SUBJECT: Review of the Lovett Modeling Protocol

Comments on Protocol for the Evaluation and Comparison of Air Quality
Models for Lovett Generating Station

Comments on Quality Assurance Plan for the Lovett Meteorological Monitoring Network

Comments on Quality Assurance Plan for the Lovett Sulfur Dioxide
Monitoring Network

Monitoring locations for Lovett Performance Evaluation

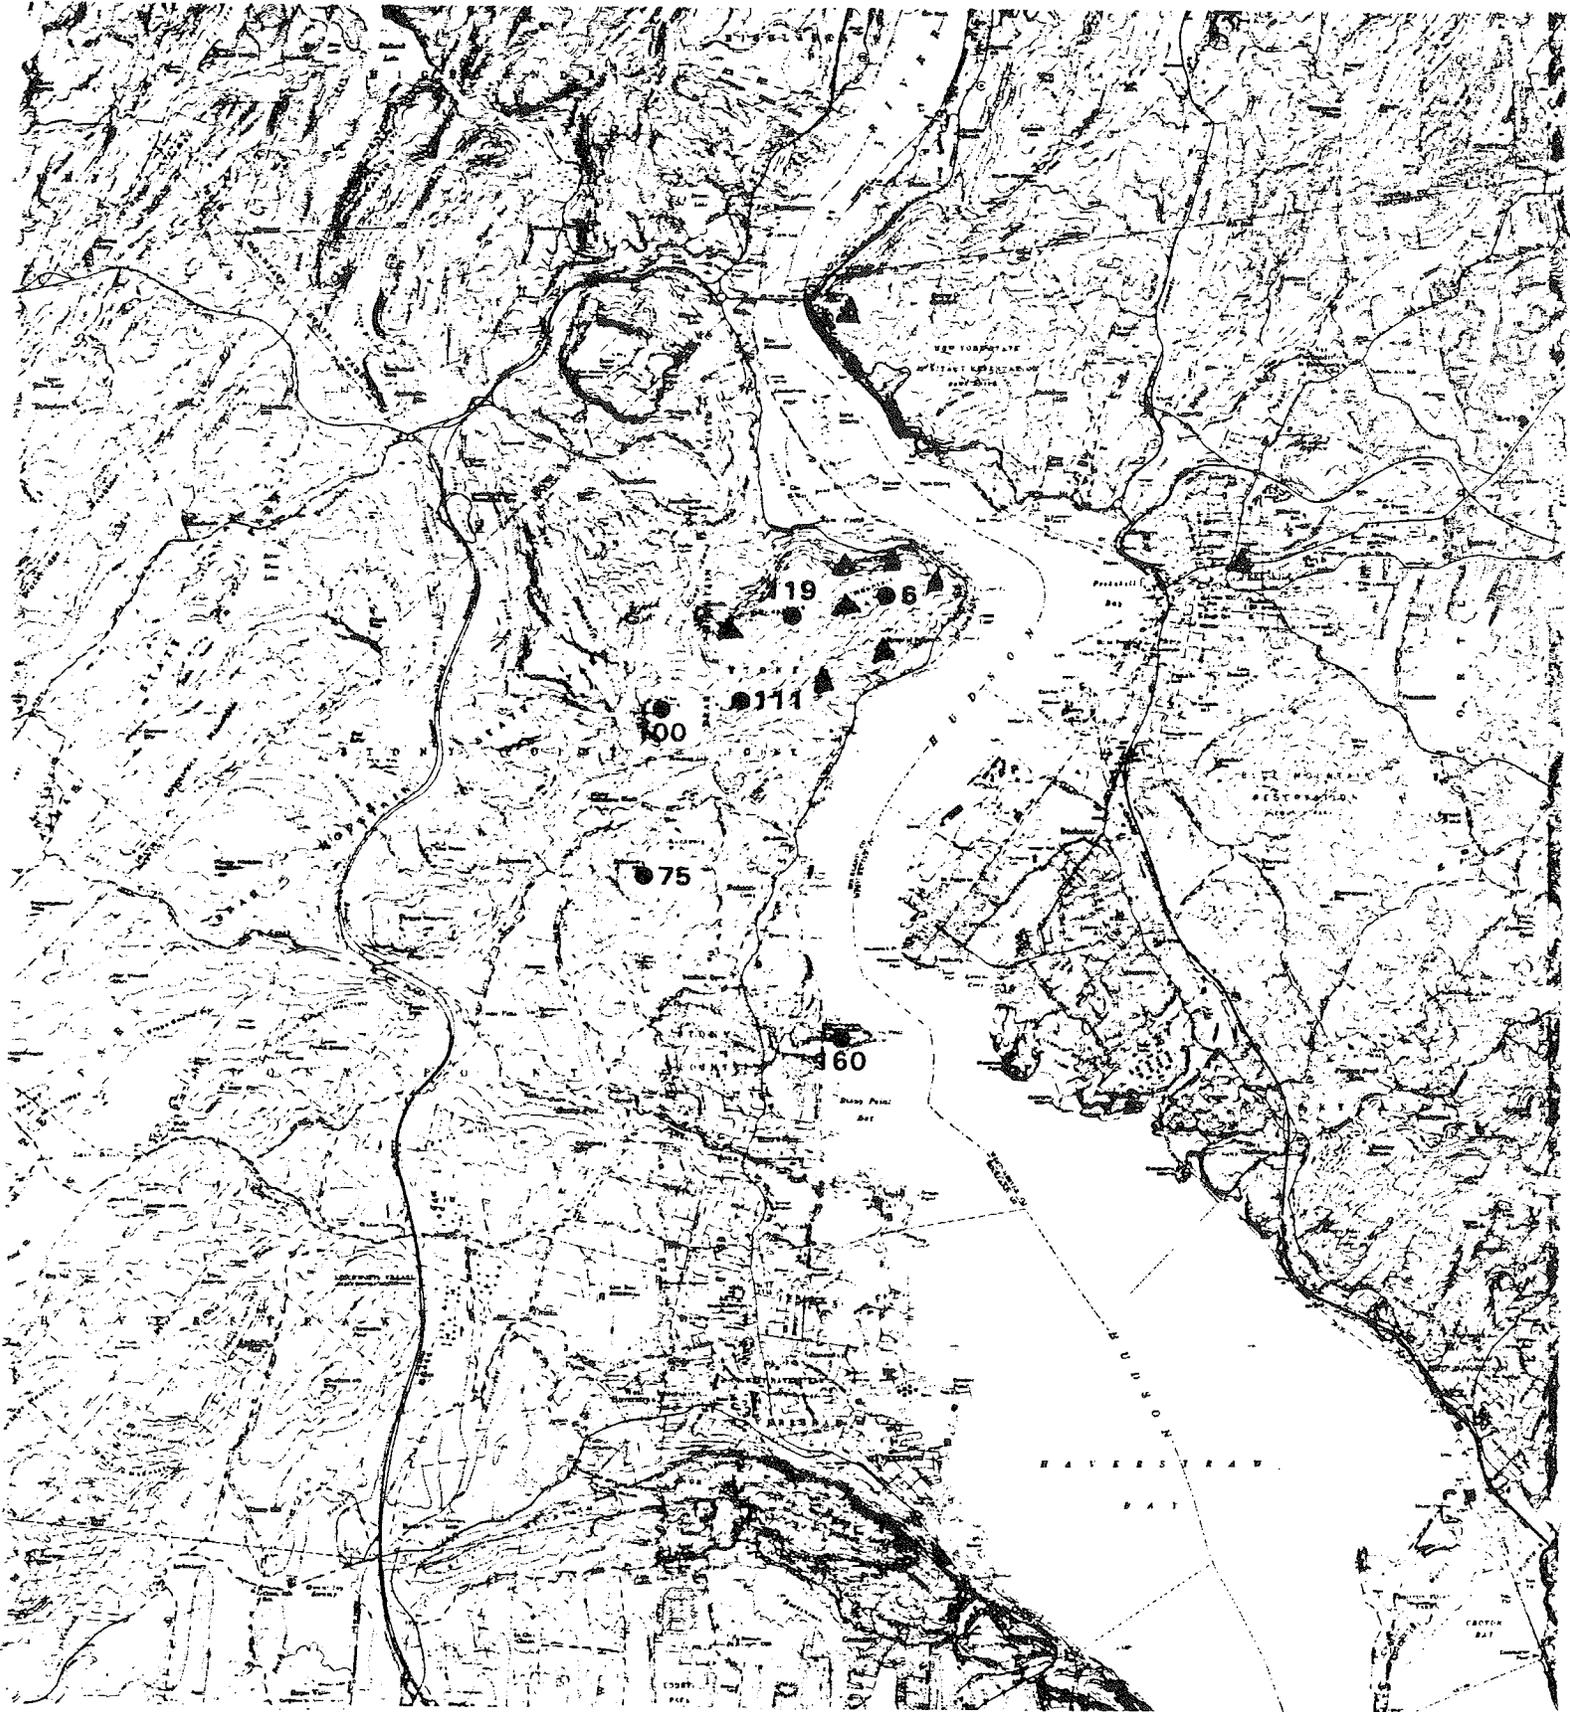
1. The proposed placement of monitors is responsive to the preliminary estimates from the contending models. However, based on experience with previous model evaluations, knowledge that has been gained from the EPA complex terrain study and other technical considerations, the proposed monitoring network does not contain acceptable coverage for conducting the performance evaluation. Additional monitors should be placed in the following areas:
 - a. Two monitors along the ridge line on Dunderhead Mountain.
 - b. One monitor at the 500-600 foot level near the end of the ridge (near the river) on Dunderhead Mountain.
 - c. Two monitors on the lee side of Dunderhead Mountain.
 - d. Two monitors on the windward side of Dunderhead Mountain (near the 500-600 foot level).

- e. One monitor in the town of Peekskill.
- f. One monitor near the beacon on Anthony's Nose (near the Bear Mountain Toll Bridge).

Suggested approximate locations for the additional monitors are shown on the attached map.
